**CERTIFICATE OF APPROPRIATENESS**

**Property:** 1234 Allston, lot 21, block 185, Houston Heights Subdivision. The property includes a historic 4,122 square foot, one and half story wood frame single-family residence and a detached garage situated on a 6,600 square foot (50' x 132') interior lot.

**Proposal:** Alteration – Construct a rear one-story, 19' by 16' addition to a two-story residence connecting the residence to the existing garage. Raise the existing two-story garage 5' and construct a two-story addition. The two-story garage addition will measure 14' wide at the front and 11' wide at the rear, 31' deep, 20' to the eave and 26'-6" to the ridge.

**WEST ELEVATION – FRONT FACING ALLSTON STREET**

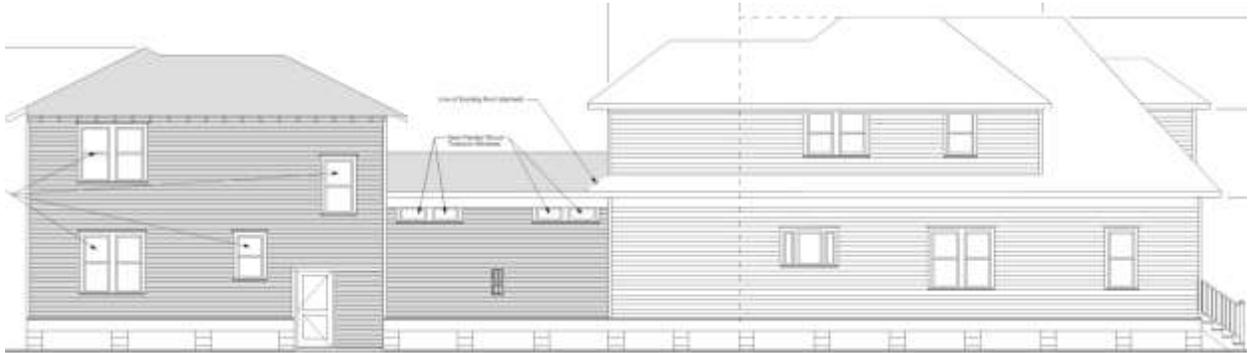
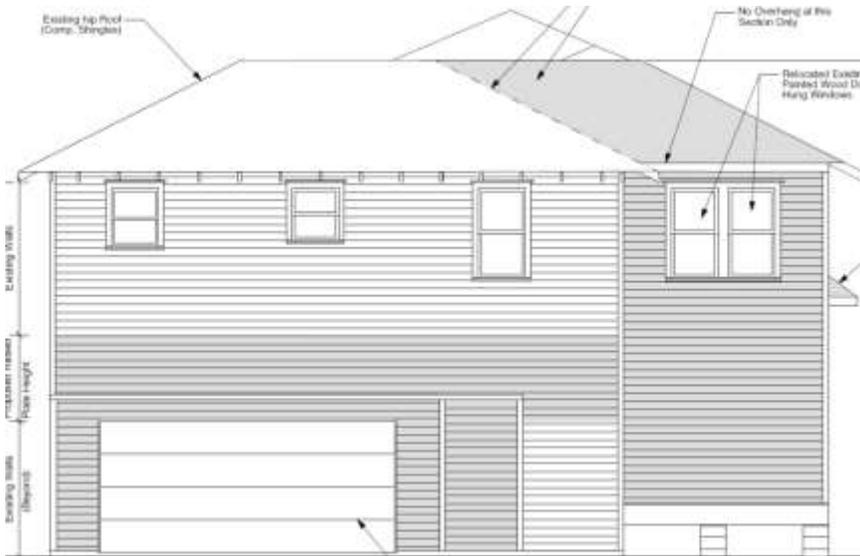
Agenda Item #36 - 1234 Allston – I **support** this application. The one-story connection between the existing two-story structure and the proposed two-story garage is sufficiently articulated, supported by the proposed clerestory windows, so that there is an evident visual distinction between the two main structures. This articulation will provide a reduction in the visual massing of the north wall and, as such, will bring the proposed structure in line with the typical massing pattern evidenced in the district.
